Oakland City Planning Commission

STAFF REPORT

Case File Numbers: PUDF10-304, V10323, TTM8047 **February 23, 2011**

The Macarthur Transit Village Stage 2 project is proposed on Parcel D of the Macarthur Transit Village (the area bounded by Highway 24 to the west, 40th Street to the north, Telegraph Avenue to the east, and West Macarthur Boulevard to the south). The proposed project includes redevelopment of the site with 90 residential units, 90 parking spaces, and usable open space. The applicant will be seeking approval of a Final Development Permit for the project, as well as variances for providing required loading off-site and reduced parking space dimensions.

1 A1.10 SITE PLAN

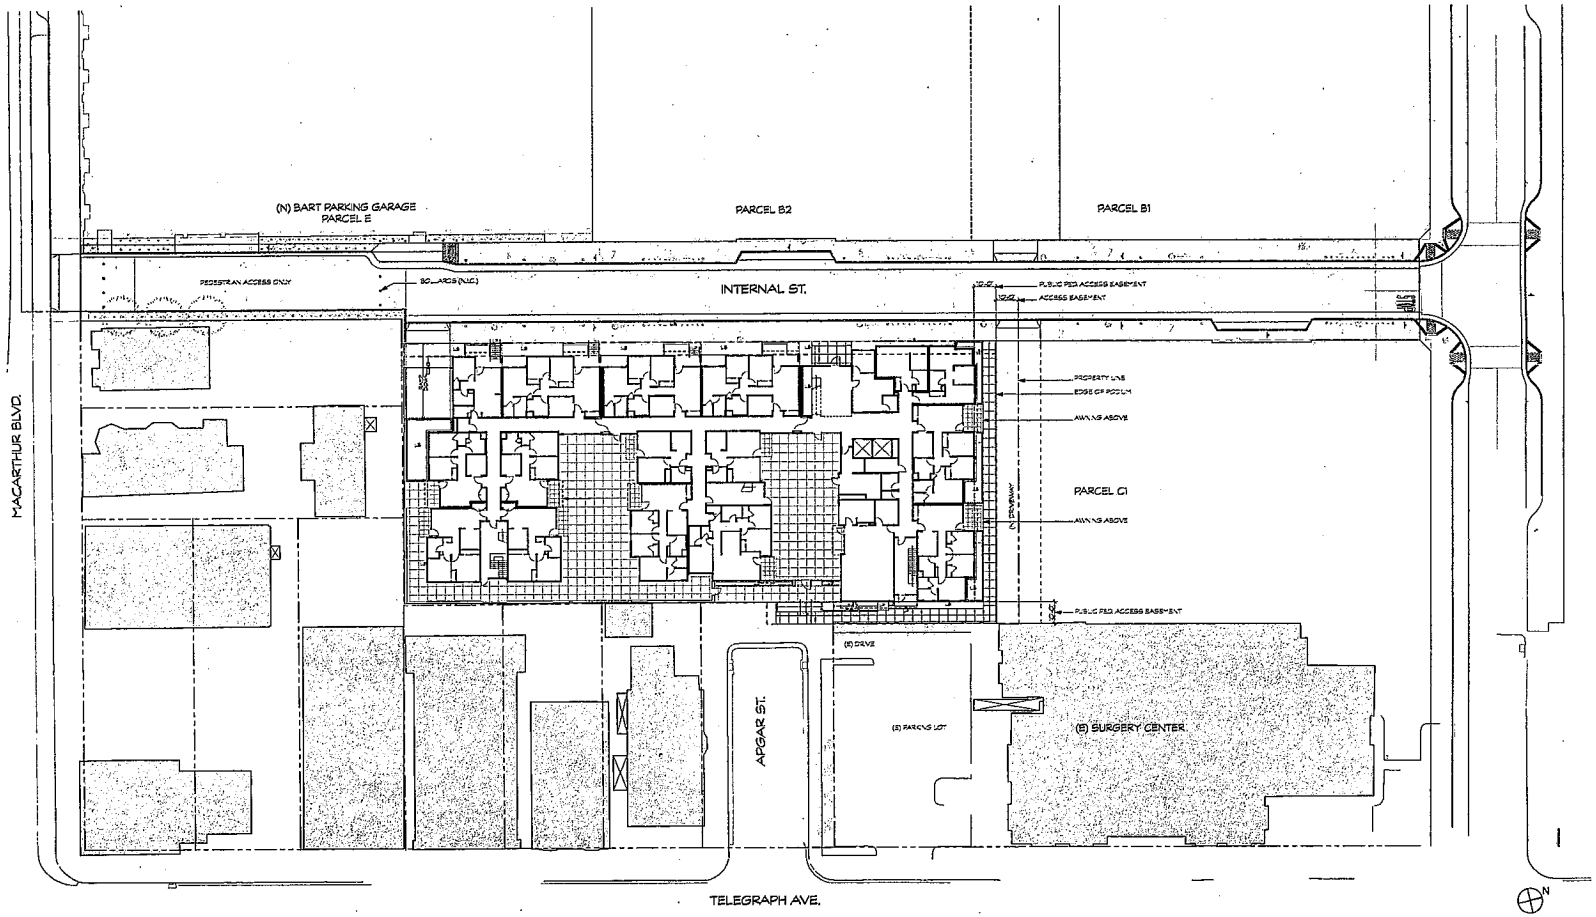
Staff supports the basic site plan, with sub-grade parking, the building fronting Internal Street and the northern property line, and front stoops along the western and northern building frontages. However, staff believes that the project should include a clear visual, if not actual, connection between Internal Street and Apgar Street at the rear of the property. Staff previously recommended aligning the building lobby and project courtyard with Apgar Street to provide a visual connection between Telegraph Avenue and Internal Street, thereby providing a more integrated feel between the existing neighborhood and the planned transit village.

The current plans indicate a subtle connection between Internal and Apgar Streets, where the lobby, courtyard and Apgar Street are connected but do not provide a clear connection into the project or between the public and private realms. The applicant has designed the Apgar Street project entry to be inviting and provide a formal-feeling entrance from that location.

A3.10

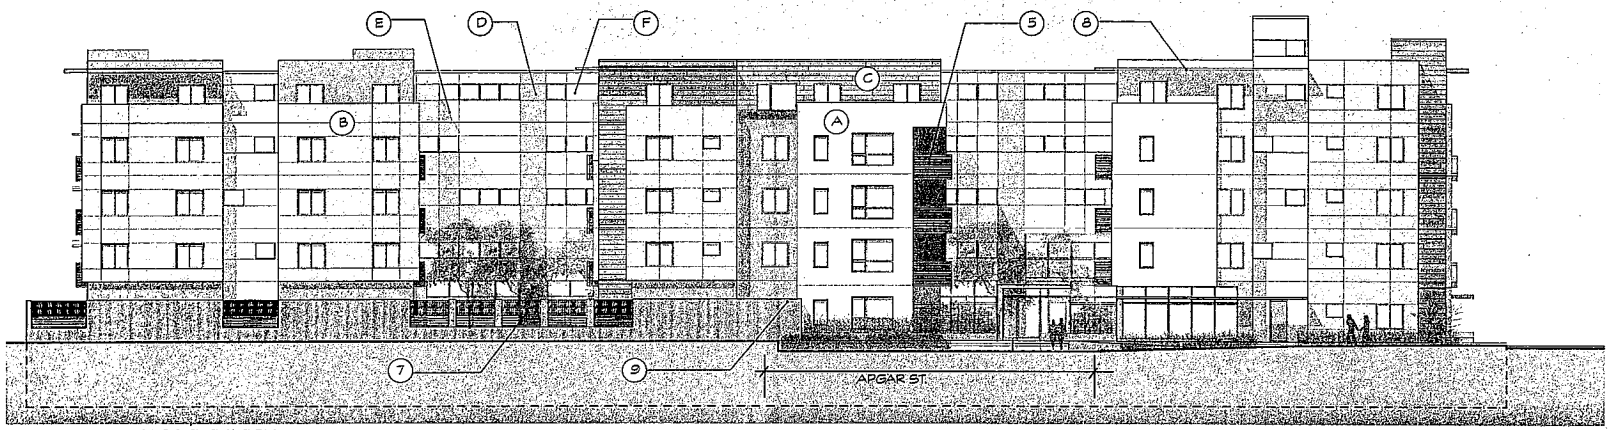
The western project elevation fronting Internal Street includes many desirable features and design details, as noted above. Staff previously recommended accentuating the northwestern corner of the building to provide a visual identity and marker. Staff specifically recommended providing more openness in the building at the corner and making the corner a tower or otherwise distinguishing it from the rest of the building.

The revised plans distinguish the northwestern corner of the building with a change in massing and rhythm of components.

Although the front of the proposed project is located along Internal Street, the rear of the project also fronts a public street, Apgar Street, and is visible from Telegraph Avenue, a major arterial street. The project is designed to include a lobby and courtyard that provide modest visual access through the site from Apgar Street to Internal Street. In addition, the project entrance from Apgar Street is designed to increase connectivity between the public and private realms. That said, staff remains concerned that the connectivity between the public and private realm and between Apgar and Internal Streets is not yet provided to the extent that it should be. Ideally, staff believes that the lobby fronting Internal Street and the internal courtyard should be aligned with each other and with Apgar Street to provide a direct visual connection between the two streets and to provide an intentional connection between Apgar Street and the project. Staff finds that the approach taken by the applicant is more subtle and seeks review and direction from the Design Review Committee, specifically this issue.

1 L1.0 **COURTYARDS**

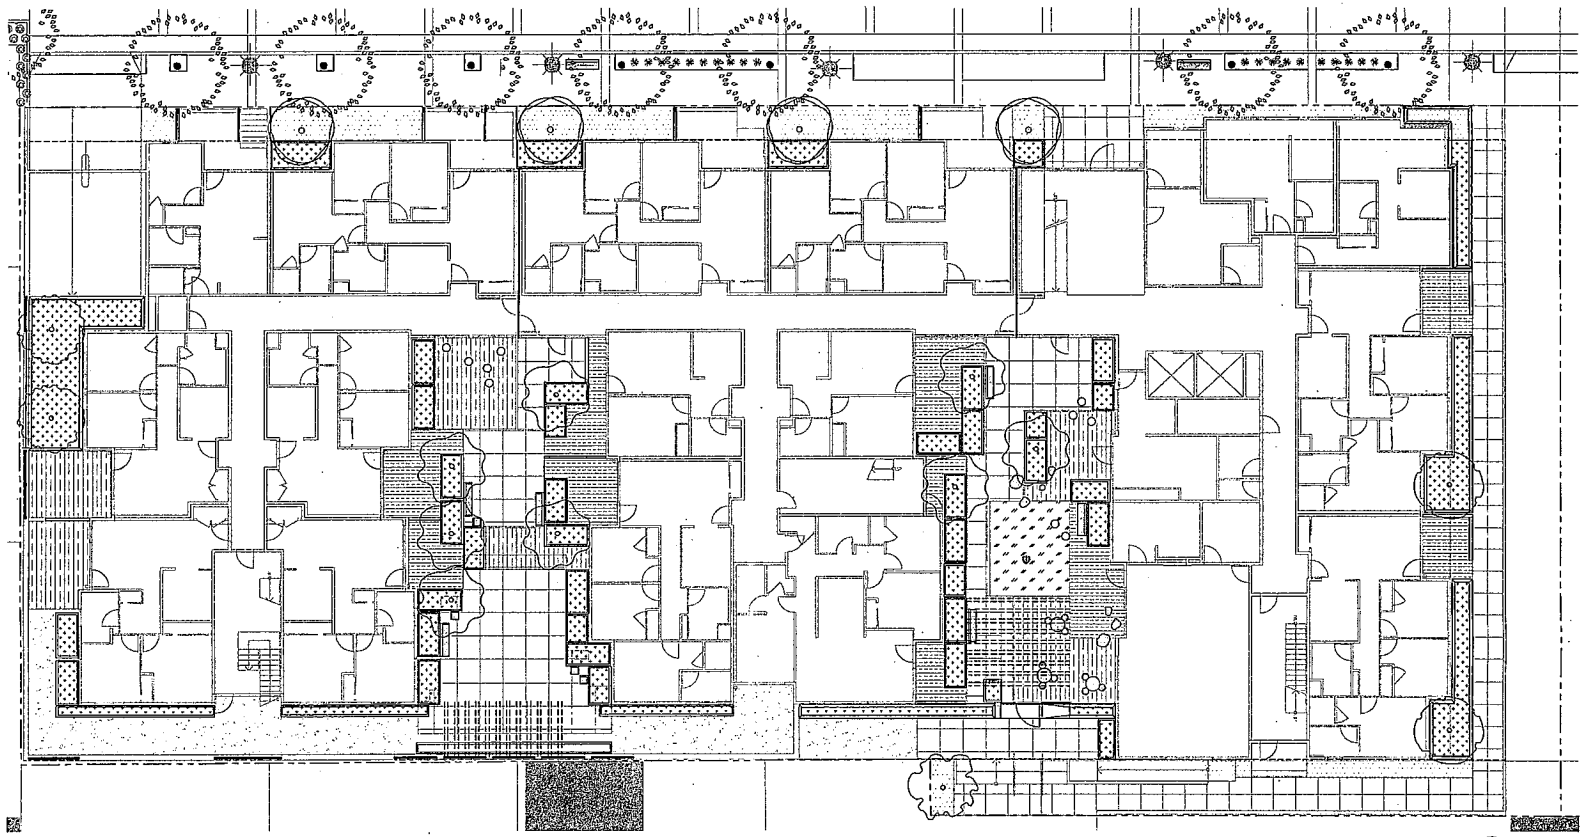
The two proposed project courtyards are attractively designed and include desirable features for a multi-family residential project. In particular, the northernmost courtyard is adjacent to the community and laundry rooms, maximizing potential use of the outdoor space. The proposed exterior building materials are finer-grain facing the courtyards, and conditions of approval could specify child-friendly materials and features, as well.

As noted above, staff is concerned that the northernmost courtyard and rear project entry are not aligned with Apgar Street to maximize the transparency of the project and the connection between the public and private realms.
